SERVICE BULLETIN

APPLICABILITY: 2017-21MY WRX NUMBER: 07-200-21

SUBJECT: Metallic Rattle Sound While Operating Horn

Bulletin Number: 07-200-21; Date: 09/13/21

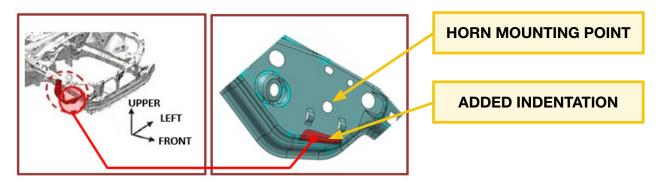
This bulletin announces the design changes to the right front wheel apron. A customer may experience a "metallic rattle" sound when operating the horn. This can be the passenger side horn mount making contact with the wheel apron creating a vibration/sound. The new apron has an added indentation to providing needed clearance for the horn. There has also been a horn stopper removed from the apron to allow additional clearance as well.

- Vehicles produced as of January 2020 will have the added indentation.
- Vehicles produced as of August 2021 will have the added indentation and the deleted horn stopper.
